Assessment of Catherine Hill Bay Water Utility's network operator's licence application

Water — Report to the Minister
September 2015

Figure A1.1 Lake Macquarie Local Environmental Plan 2004, South Wallarah Peninsula Part 11

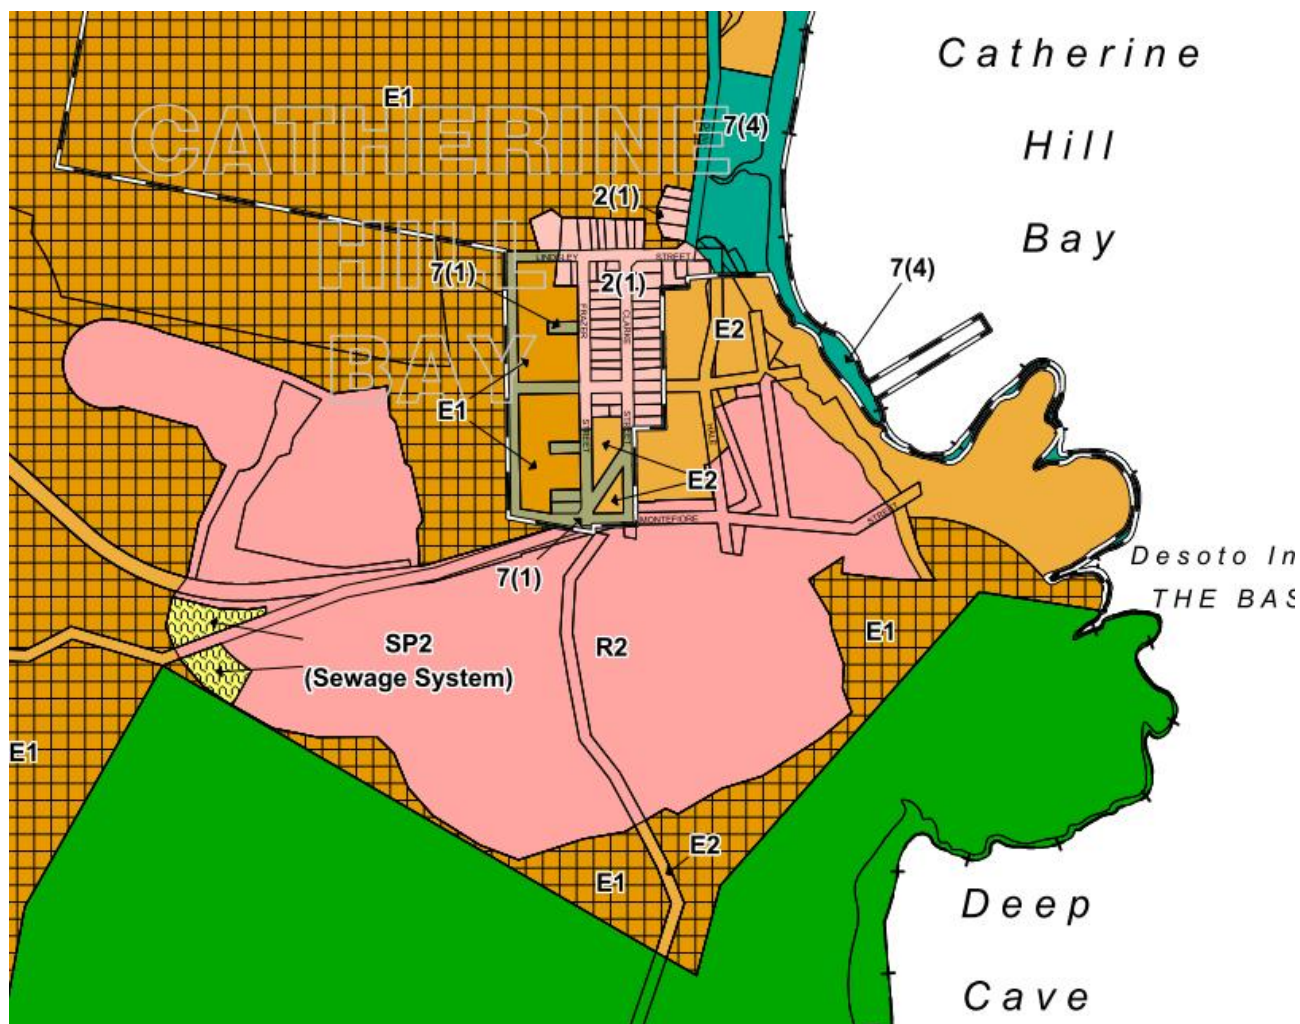
The proposed works will be undertaken on land zoned both SP2 (for the STP) and R2 (for the recycled water reticulation system and effluent irrigation, as show on the figure below.

Under Clause 106(1) and (2) of the ISEPP, development for the purposes of sewage treatment plants and water recycling facilities may only be carried out without development consent on land in a prescribed zone or any land that is ancillary to an existing land use. Prescribed zones include land zoned SP2, but not R2 under the ISEPP.

Figure A1.2 NSW Coastal Protection Act 1979, Map 4

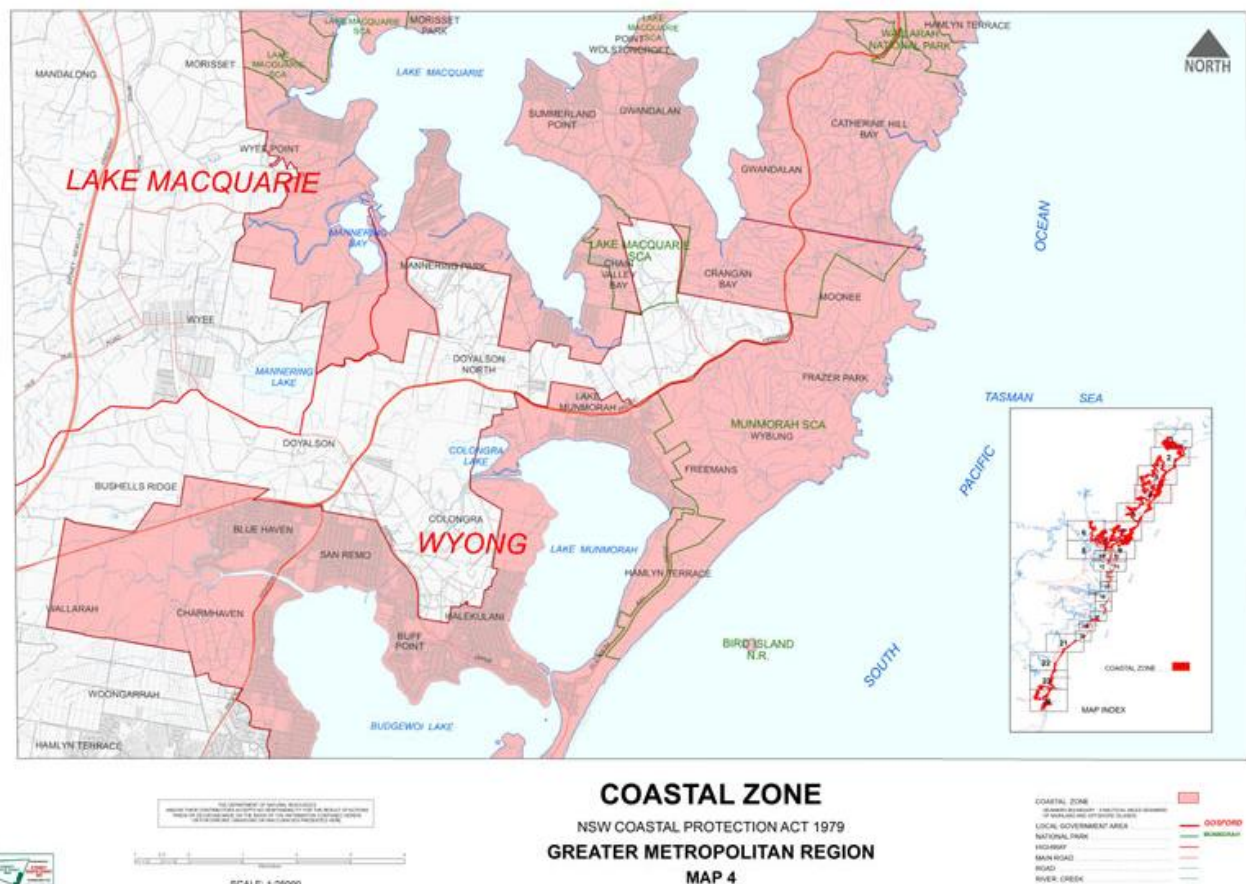
State Environmental Planning Policy No 71 – Coastal Protection (SEPP 71) applies to the coastal zone in NSW, which includes the site of the proposed development as shown on the figure below.

Part 2 of SEPP 71 outlines matters for consideration by consent authorities when determining an application to carry out development on land in the coastal zone. These include considerations such as impacts to public access to coastal foreshores, amenity impacts, impacts to coastal processes and the likely impacts of the development on the water quality of coast waterbodies.
